**Item No.** 8.1.1  
**Design Review Committee**  
**April 14, 2016**

**SUBJECT:** Case 20371 – Substantive Site Plan Approval – Mixed-use Development at  
1474 Brenton Street & 1469-73 South Park Street, Halifax

**SOUTH ELEVATION**

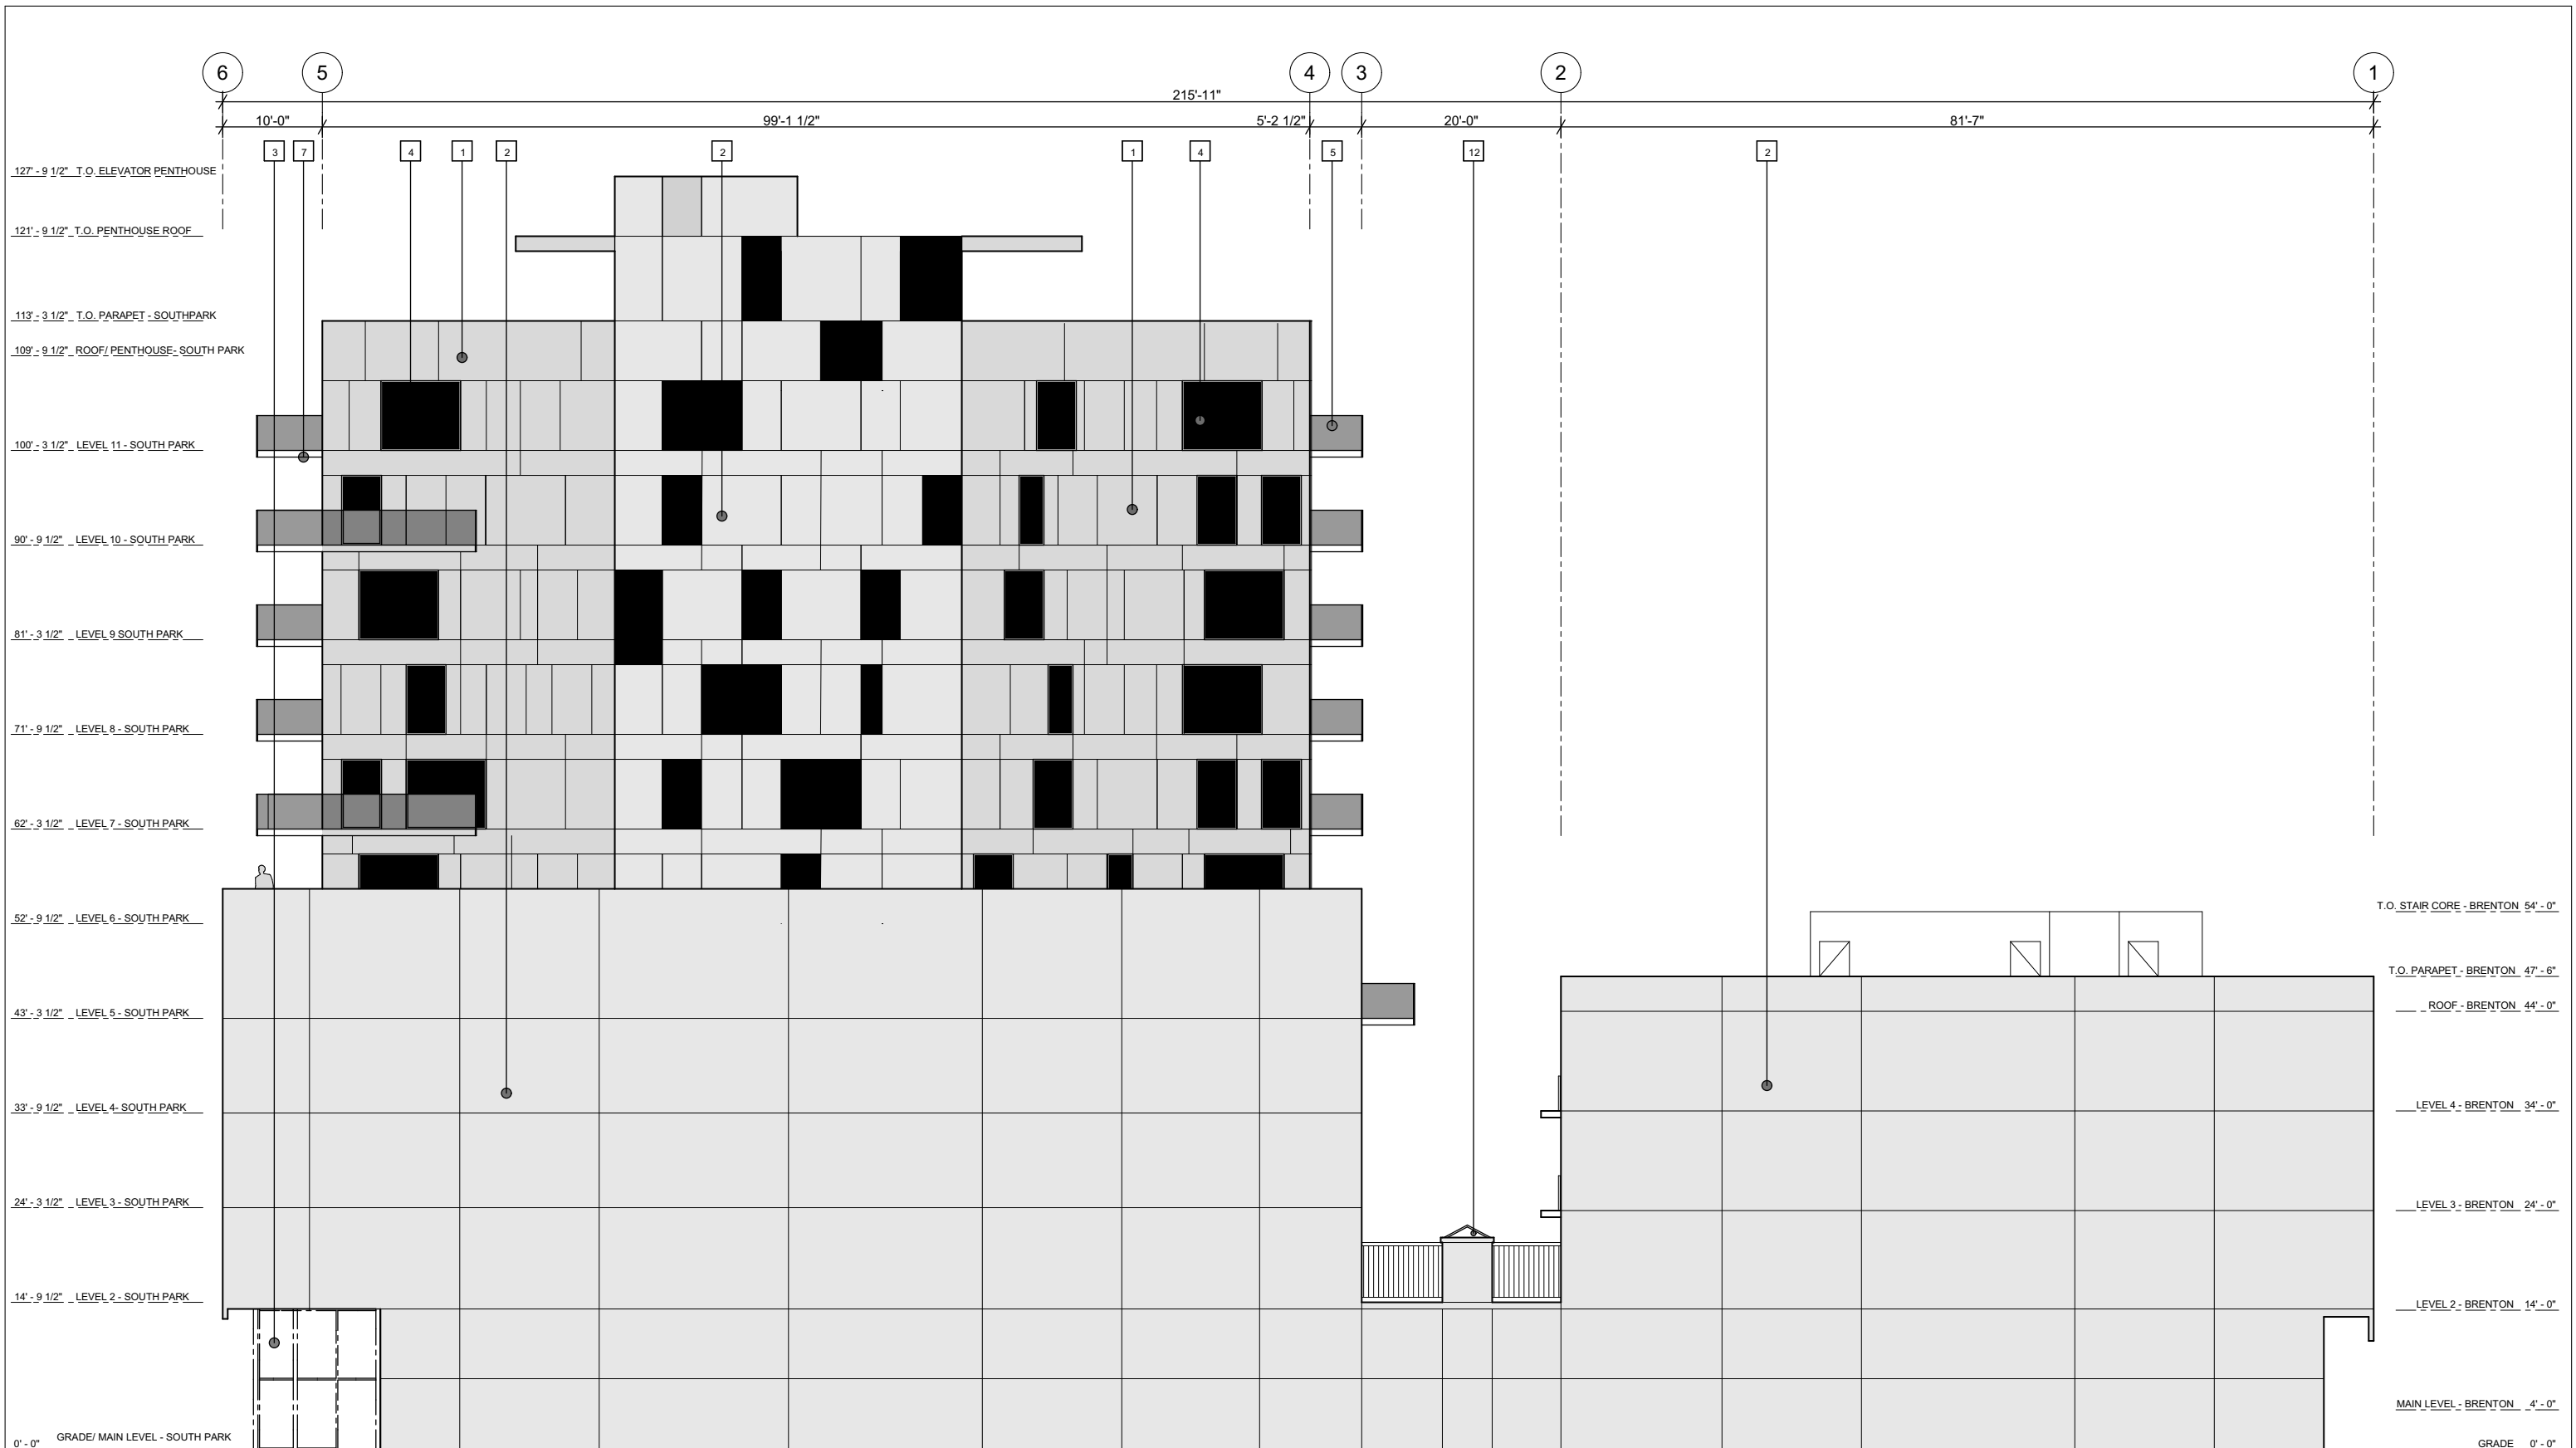
Wind speeds predicted for the summer are slightly higher than desired for public terraces intended for passive activities. If tall planters or trees are proposed along the perimeter of the terraces, that would reduce wind speeds in the area to more comfortable levels in the summer. Screens, approximately 20-30% porous, may also be considered in place of landscaping. It is recommended that if either of these features are used, that they be at least 2 m tall for good wind control efficacy.

Image 3: Main and Penthouse level plans showing main public areas of the development

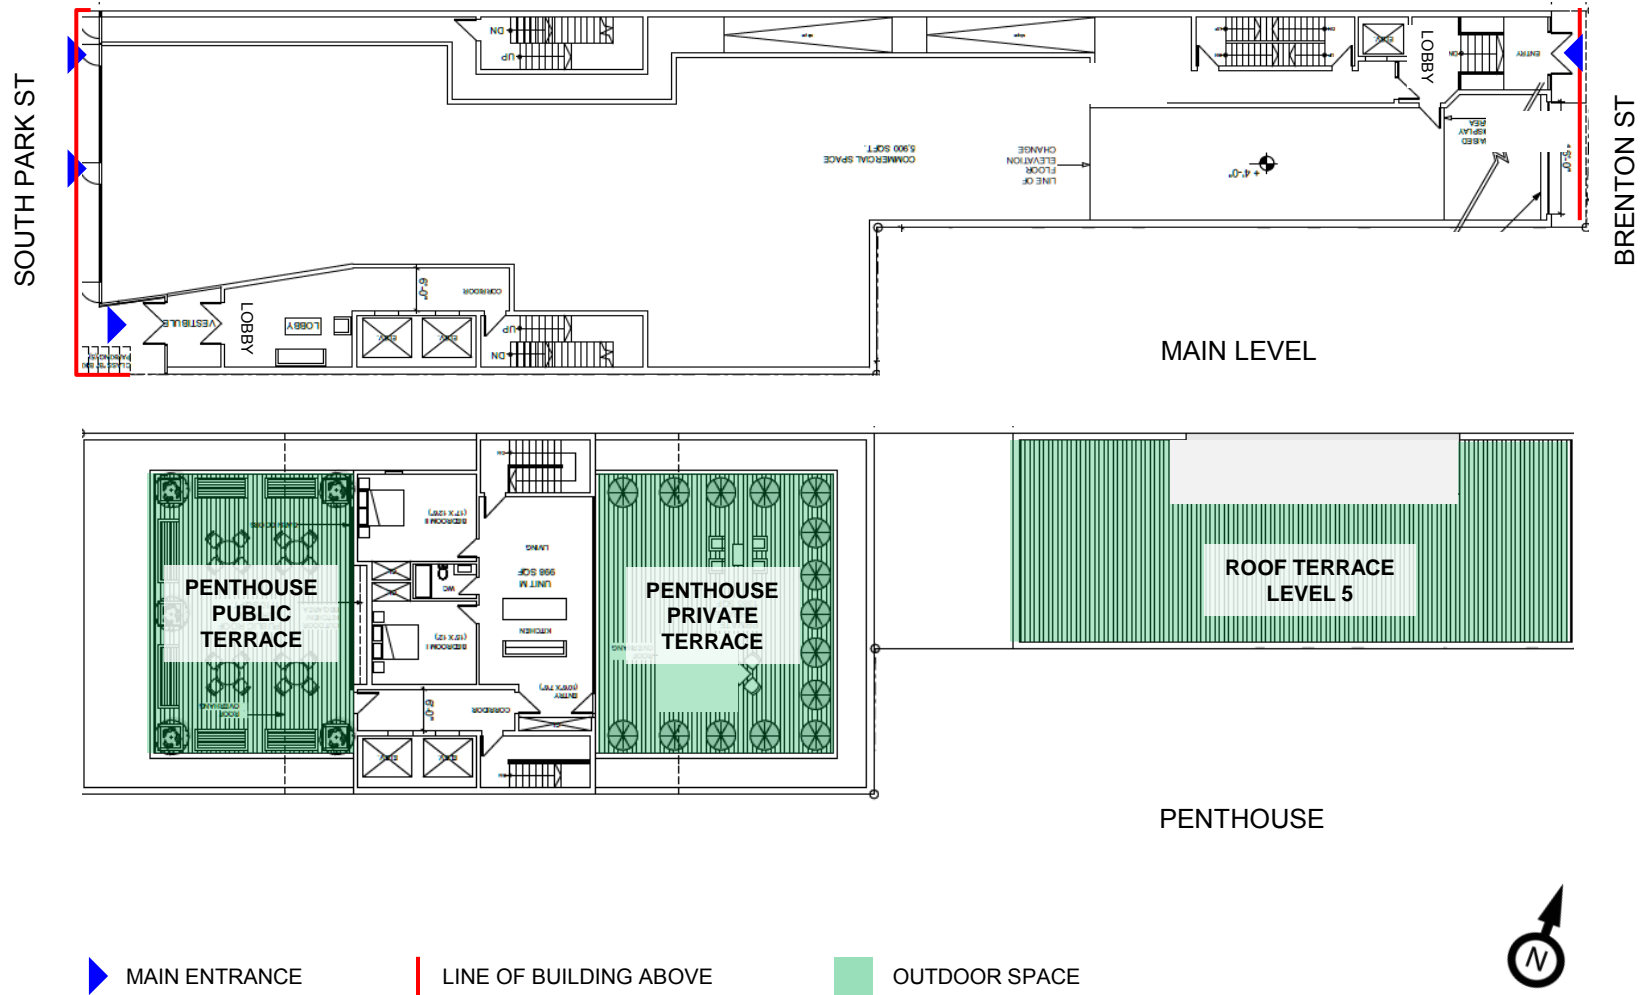
This section discusses wind conditions expected after the completion of the proposed project. Since the site is sheltered from most predominant winds by the existing surroundings and the proposed development has a narrow façade exposed to the prevailing west and northwest winds, it is expected that the construction of the proposed buildings will bring very little change to the local wind microclimate. The floor plans in Image 3 may be referred to in conjunction with the following discussion.
